Subject: Duke Energy Carolinas, LLC
McGuire Nuclear Station, Units 1 and 2
Docket Nos. 50-369 and 50-370

Response to Request for Additional Information Related to the Application for Technical Specification Change Regarding Risk-Informed Justification for the Relocation of Specific Surveillance Frequency Requirements to a Licensee Controlled Program

UPDATED TECHNICAL SPECIFICATION AND BASES PAGES

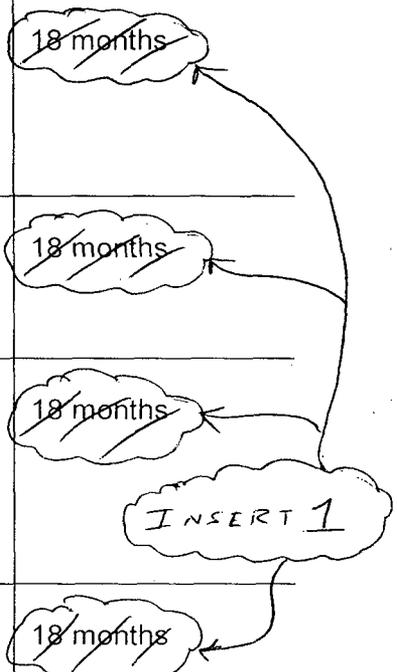
SR 3.6.6.7 Verify each spray nozzle is unobstructed.	Following activities which could result in nozzle blockage
